18-OCT-2024 10:53 C:\Users\Anthony.Reass\Roosi Transportation Group, Inc\Projects - Documents\Project Files\18_105 De\DOT Laurel Design\CADD\Sheets\501.dgn

ADDENDA / REVISIONS		NOT TO SCALE	LAUREL RAMBLE PHASE II	CONTRACT	BRIDGE NO.	N/A	INDEX OF SHEETS	SECTION
				T202120006	DESIGNED BY: A. REASS			ROSSI
				COUNTY	CHECKED BY: S. MCEVILLY	SHEET NO.		
				SUSSEX		2

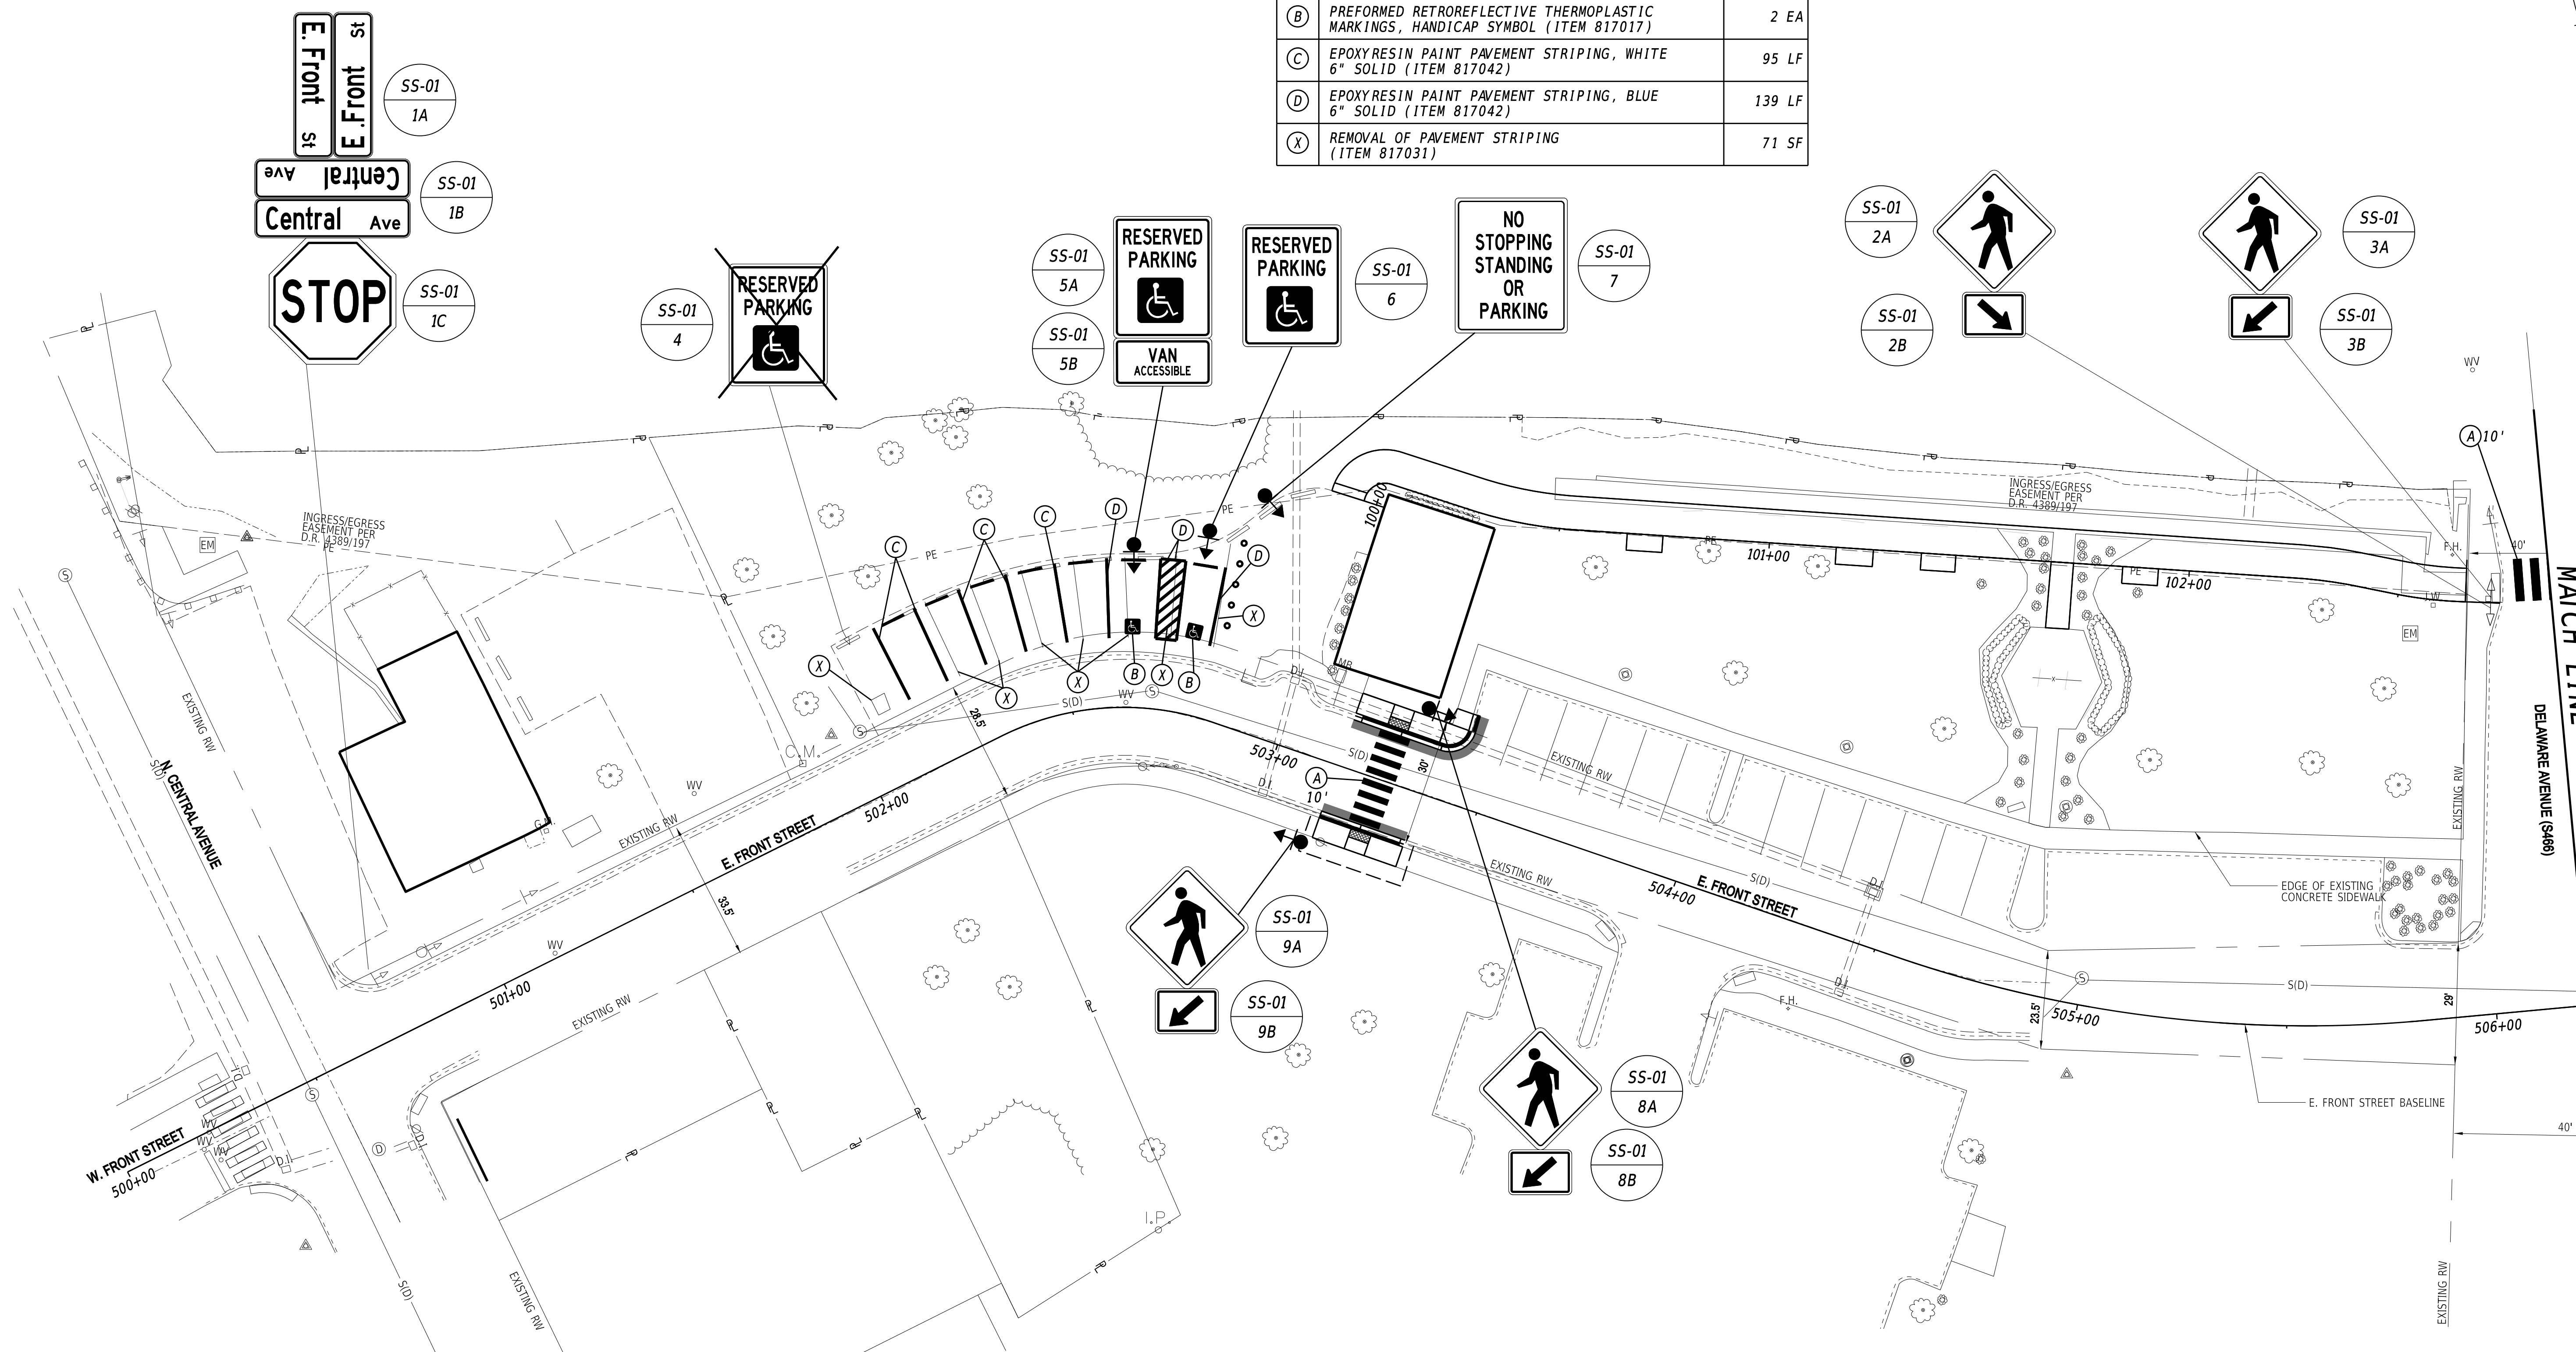
ADDENDA / REVISIONS		SCALE 0 20 40 60 FEET	LAUREL RAMBLE PHASE II	CONTRACT T202120006	BRIDGE NO. N/A	SIGNING, STRIPING AND CONDUIT PLAN	SS-01
				COUNTY SUSSEX	DESIGNED BY: A. REASS		CHECKED BY: S. MCEVILLY
							SHEET NO. 29

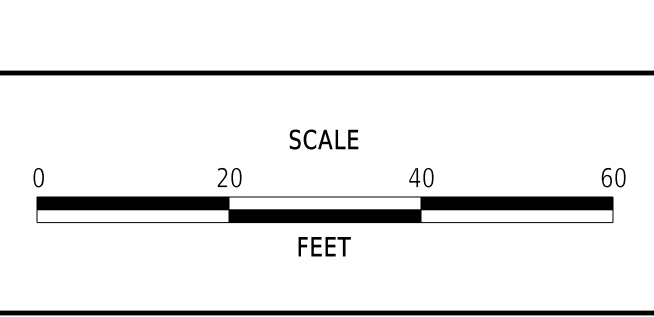
ADDENDA / REVISIONS

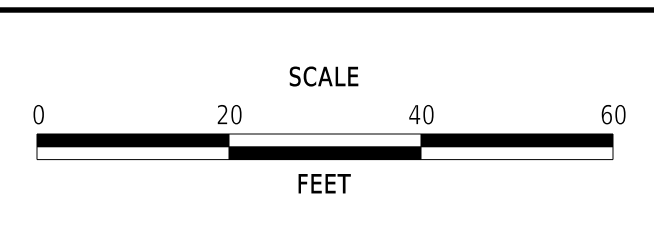
ADDENDA / REVISIONS
